Addendum NO. 2
May 31, 2019

“Achieve Early College Reroof and HVAC Upgrades”

To:	CHANIN Engineering	Date:	05-30-2019
From:	Antonio Anzaldua	AVO:	35392.001
Email:	aanzaldua@halff.com	Project:	ACHIEVE EARLY COLLEGE REROOF AND HVAC UPGRADES
Subject:	ELECTRICAL REVISIONS

02 ELECTRICAL REVISED PARTIAL ONE LINE DIAGRAM

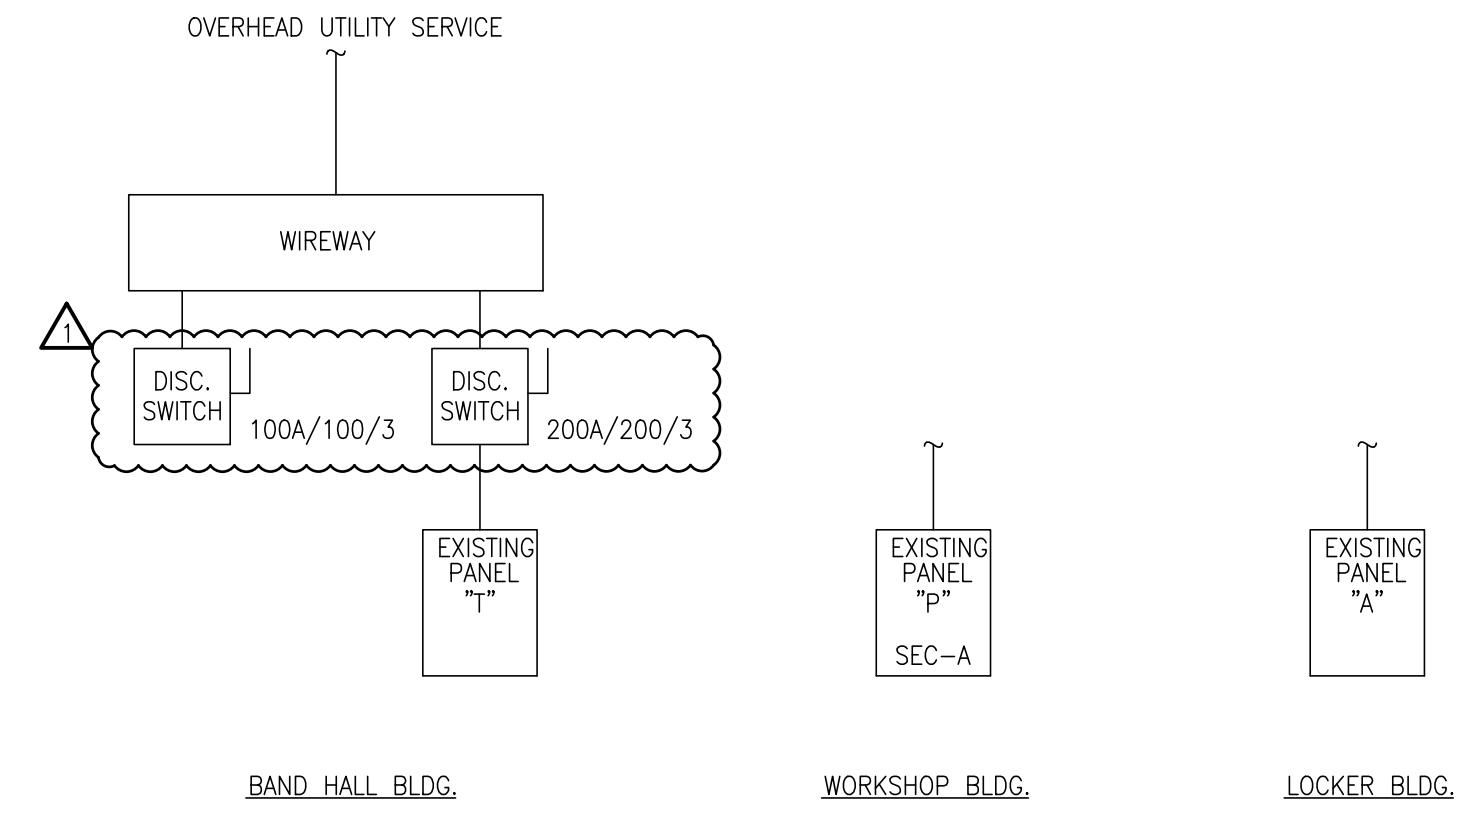
- ITEM 1. Refer to Sheet ED2.01
 - a. Electrical one-line diagram has been edited.
 - b. Electrical one-line diagram key notes have been modified.
- ITEM 2. Refer to Sheet ED2.02
 - a. Panelboard schedules were edited.
- ITEM 3. Refer to Sheet E2.01
 - a. Panelboard schedules were edited.
- ITEM 4. Refer to Sheet M2.01
 - a. Modified notes on schedules
- ITEM 5. Clarification:
 - a. The existing building automation system is a JCI-Metasys. Contractor to disconnect existing controls to existing equipment and reconnect to new equipment.

- CONTRACTOR TO VERIFY IF SWITCHES/ENCLOSED BREAKER/PANELBOARDS ARE ADEQUATE FAULT CURRENT RATINGS(KAIC). SHORT CIRCUIT CALCULATION WAS MADE BASED ON SITE SURVEY. ISC = 51,440 AIC FROM THE UTILITY XFMR TO THE MAIN SERVICE DISCONNECT. CALCULATIONS BASED ON SITE ASSESSMENT, OWNER SHALL COORDINATE A SHORT CIRCUIT AND ARC-FLASH STUDY TO VERIFY THE SYSTEM AND CONFIRM THAT THERE ARE NO NEC VIOLATIONS.
- CONTRACTOR SHALL DEMOLISH EXISTING 400A/NEMA 3R FUSIBLE DISCONNECT AND FURNISH AND INSTALL A JUNCTION BOX WITH A TERMINAL BLOCK 3-LBC163106, GND1-LBC162104.
- RECONNECT EXISTING AMERICAN ELECTRIC EXCHANGE CONTROLS MODULE.
